April 19, 2021

**Re: Planning Review #3
Application SP-8-19
Preliminary and Final Site Plan
Block 206, Lots 14 & 15
495 Springfield Avenue
Elshiekh Enterprises, LLC
DD Downtown Development Zone**

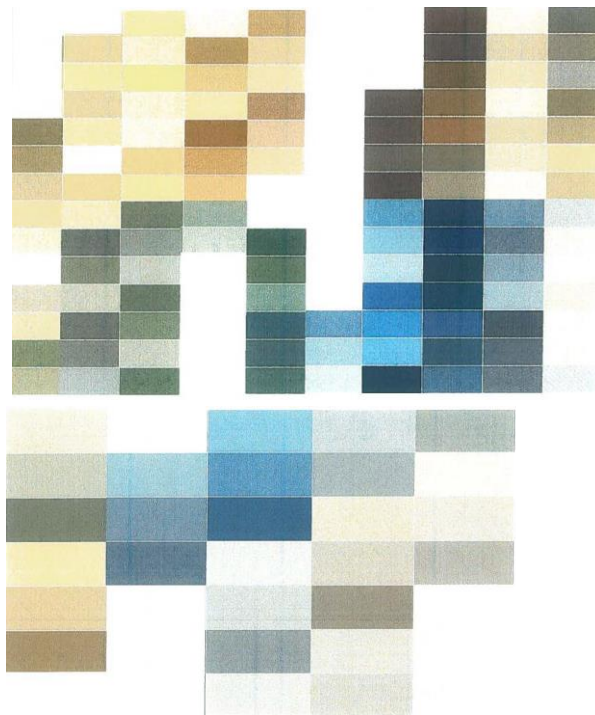
10. The applicant should provide testimony regarding the architectural design of the building. The proposed scale and massing, façade treatment, detailing, and materials are generally compliant with standards enumerated in Part 19. However, the applicant should specify the colors of the materials. We additionally recommend that the applicant provide colored 3D renderings and material samples at the time of the hearing. The Board should note that Section 19.5.7.A.4 recommends following colors and hues for buildings in downtown:

The applicant has submitted colored renderings for an older version of the Architectural Plans dated 7/9/2020, which seem to utilize recommended colors. The applicant shall provide material specifications with color hue names/numbers to confirm compliance.

This comment has been satisfied. Prior to the March 3, 2021 Planning Board hearing, the applicant had submitted material specifications. It is our opinion that the proposed materials and colors are conforming with downtown design standards.
